#### CONSTRUCTION SUMMARY

# The Villages in Stayner - Zancor Homes (Stayner) Limited

#### THE GLEN 50-06

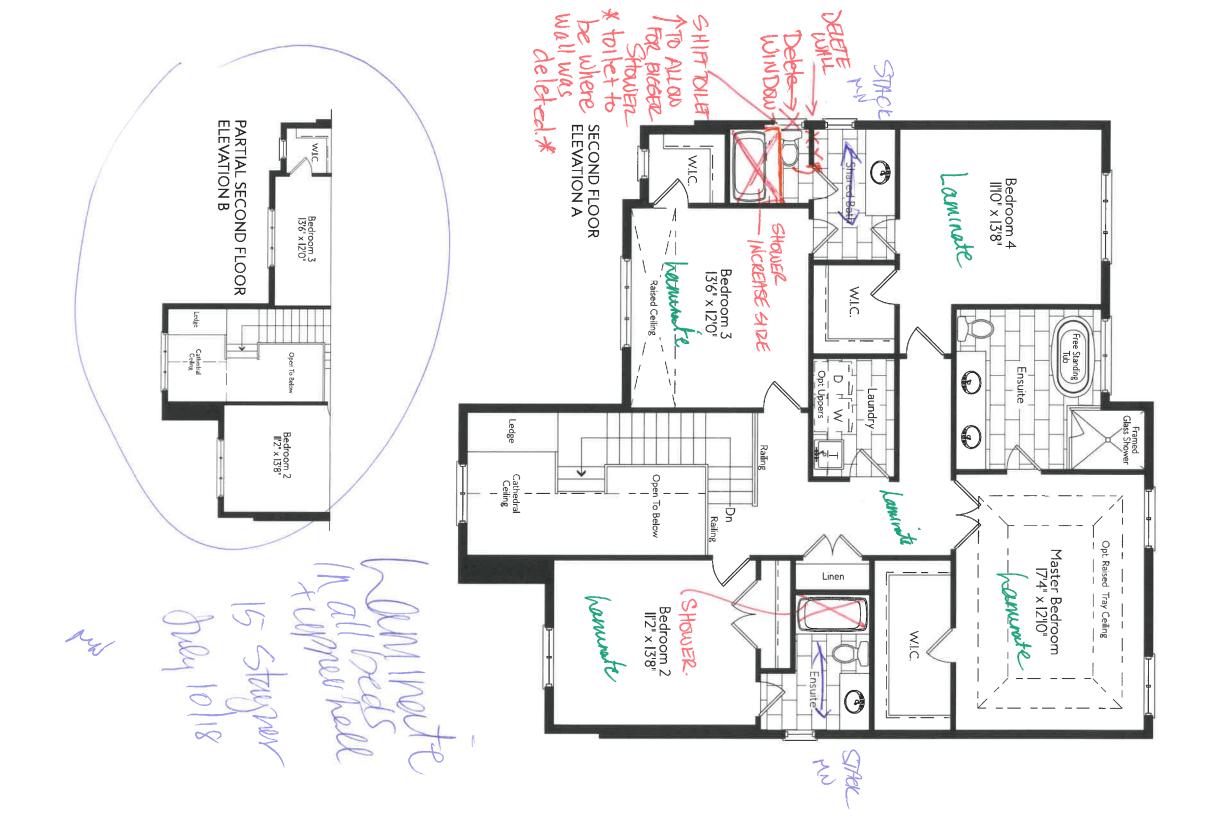
13Jul18	5887 RELOCATE DOOR TO BASEMENT AS PER SKETCH ***IF POSSIBLE (HOMEOWNERS ARE AWARE THAT BASEMENT STAIRS ARE SPRUCE, OPEN TREAD, PAINTED)
	13Jul18	5886 ROUHIN FOR FUTURE BASEMENT BATHROOM - SEE LOCATION ON SKETCH
	13Jul18	1
	13Jul18	l .
	13Jul18	
	13Jul18	
	13Jul18	5881 OAK STAIRS IN LIEU OF CARPET GRADE
	13Jul18	5880 SHARED BATH - INSTALL SHOWER IN LIEU OF TUB WITH MAAX HALO SLIDING DOOR GLASS SYSTEM
	13Jul18	5879 ENSUITE - INSTALL SHOWER IN LIEU OF TUB WITH MAAX HALO SLIDING DOOR GLASS SYSTEM
	13Jul18	5878 SHARED BATH - INCREASE THE SHOWER BY APPROX 1 FOOT
	13Jul18	5877 SHARED BATH - DELETE WALL AND WINDOW BESIDE TOILET AND SHIFT OVER TOILET
	13Jul18	5876 ADDITIONAL LAUNDRY ROUGHIN FOR FUTURE STACKABLE WASHER AND DRYER **INCLUDES ELECTRICAL, VENTING, DRAINS & WATER SUPPLY
	13Jul18	5875 ELECTRICAL - ADD PLUG IN BASEMENT FOR FUTURE STOVE (40 AMP)
	13Jul18	5874 ELECTRICAL - ADD PLUG IN BASEMENT FOR FUTURE FRIDGE

13Jul18	5873 ELECTRICAL - ADD PLUG FOR FUTURE FREEZER IN SERVERY
	13Jul18	5872 KITCHEN - DEEP UPPERS ABOVE FRIDGE WITH GABLES
	13Jul18	5871 KITCHEN - 36 INCH STOVE OPENING
	13Jul18	5870 KITCHEN - DELETE AND RELOCATE CABINETS FROM REAR EXTERIOR KITCHEN WALL AND ADD THE BASE CABINETS TO THE ISLAND  ***SPACE BETWEEN REAR EXTERIOR WALL AND END OF ISLAND TO BE 3 FEET
	15,0118	MOVE SINK & DISHWASHER TO ISLAND ***SINK TO BE CENTRED IN ISLAND  CENTRE STOVE ON WALL
	13Jul18	
	13Jul18	
Notes	_	ı
